PRELIMINARY/FINAL DRAINAGE REPORT

**JACKSON OFFICE WAREHOUSE & STORAGE
BUILDINGS DEVELOPMENT
ROCKY MOUNTAIN INDUSTRIAL PARK
FILING NO. 1A, LOT 2**

ADP Project No.170602
January 31, 2018
PCD File No. PPR-17-057

JACKSON OFFICE WAREHOUSE & STORAGE BLDGS
8140 SANDY COURT
EL PASO COUNTY, COLORADO
EXIST & DEVELOPED DRAINAGE PLAN

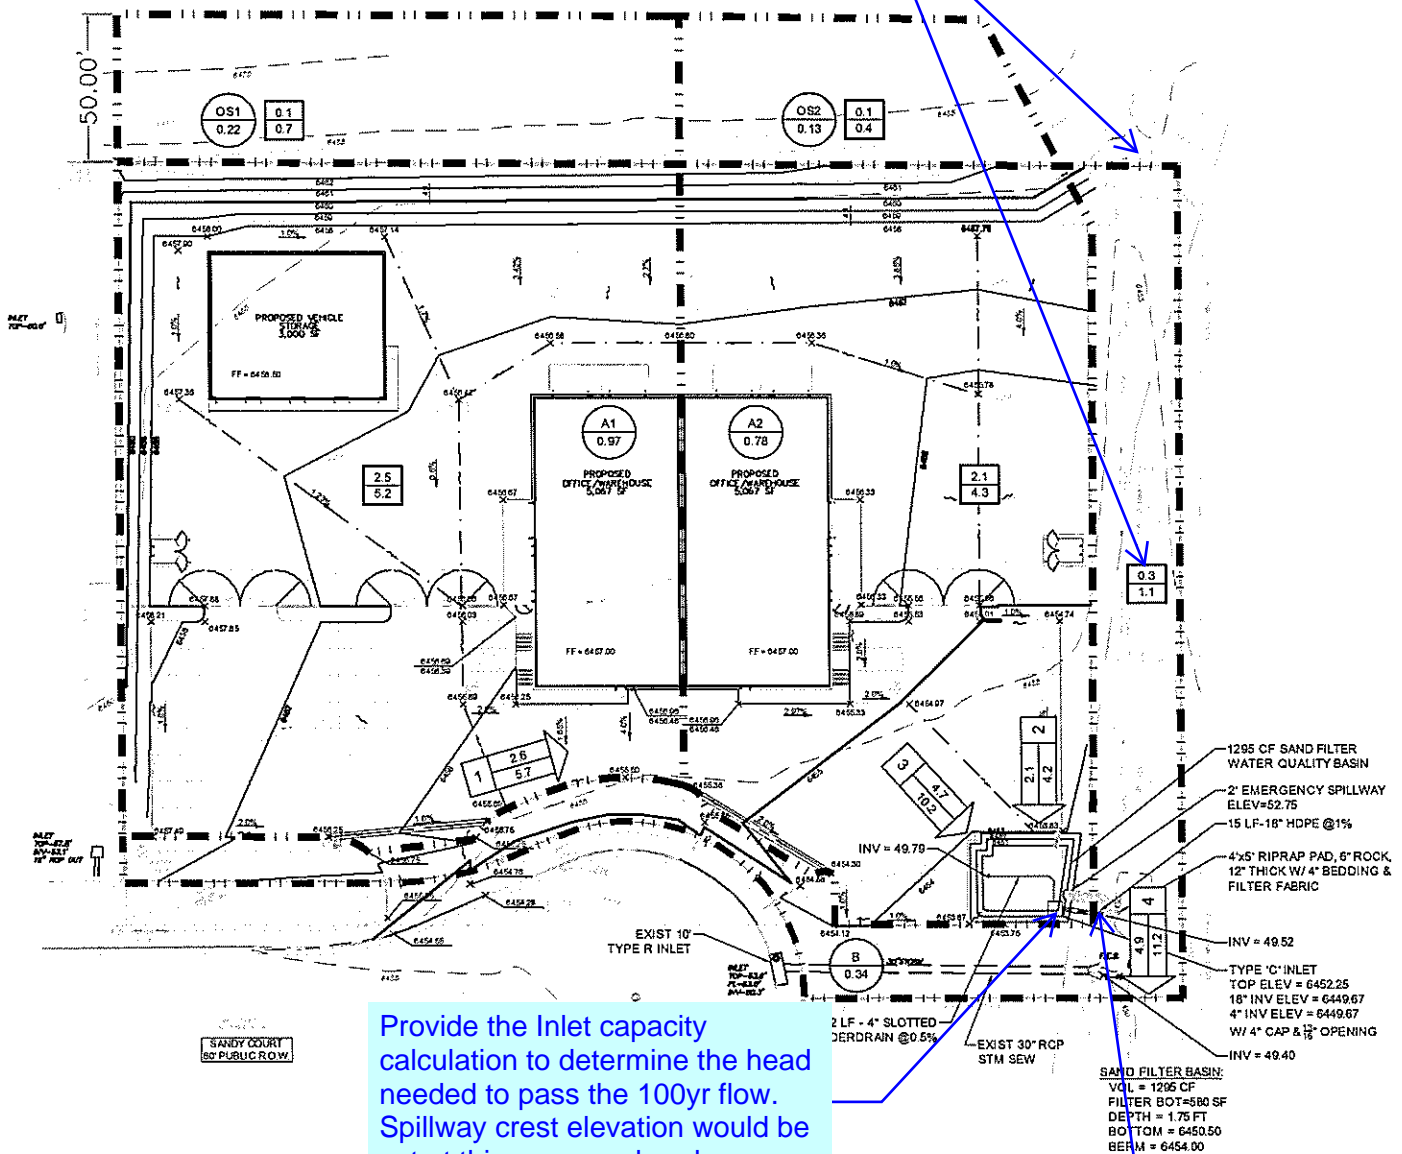
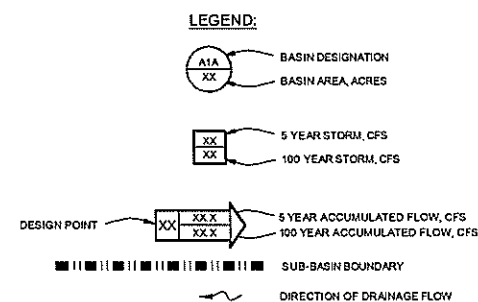
Submit the drainage as full size instead of 11x17

Adjust the offsite flow being conveyed by the channel upstream of DP4. See the Rocky Mountain FDR proposed condition DP2.

Provide the Inlet capacity calculation to determine the head needed to pass the 100yr flow. Spillway crest elevation would be set at this pressure head.

Callout what the developed condition flow is at this point w/in the Rocky Mountain FDR .

The DP4 flow rate must be equal to or less than the Rocky Mountain FDR or else the SFB may need to restrict the release rate to equal the Rocky Mountain FDR.
